## **RESPONSE TO REVIEWER 1:**

*The manuscript by Tiwari et al. presents the use of a novel metric, SPAEF, for estimating the spatial variability of hydrological variables during hydrological model calibration. Various calibration strategies, including stepwise calibration and traditional global optimization methods, were employed. To enhance clarity and conciseness, the abstract and introduction should be streamlined to ensure that readers can easily grasp the take-home messages from the study. Some introductory content may be relocated to other sections. Furthermore, it is essential to clearly and succinctly illustrate the novelty of this study.*

## **RESPONSE TO REVIEWER 2:**

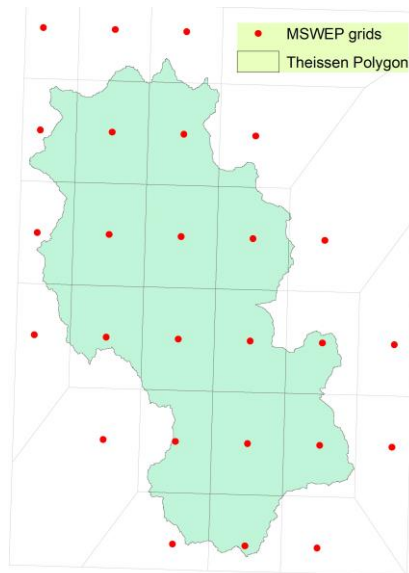
*Line 177: Please explain the selection of the Thiessen polygon method. Does the elevation change the precipitation (lapse rate)?*

The Thiessen polygon method is selected to interpolate the meteorological data spatially, the values recorded at the station nearest to a specific cell is allocated to that respective cell. When Thiessen polygon is applied on a gridded data, the polygons generated outlines the area where a specific grid cell is the closest. Therefore, the Thiessen polygons align with the precipitation grid and here we can see that the application of a Thiessen polygon is equivalent to the grid.

"with vertical precipitation gradient of 1mm/100m and vertical temperature gradient of -1°C/100m." Lines 151-152
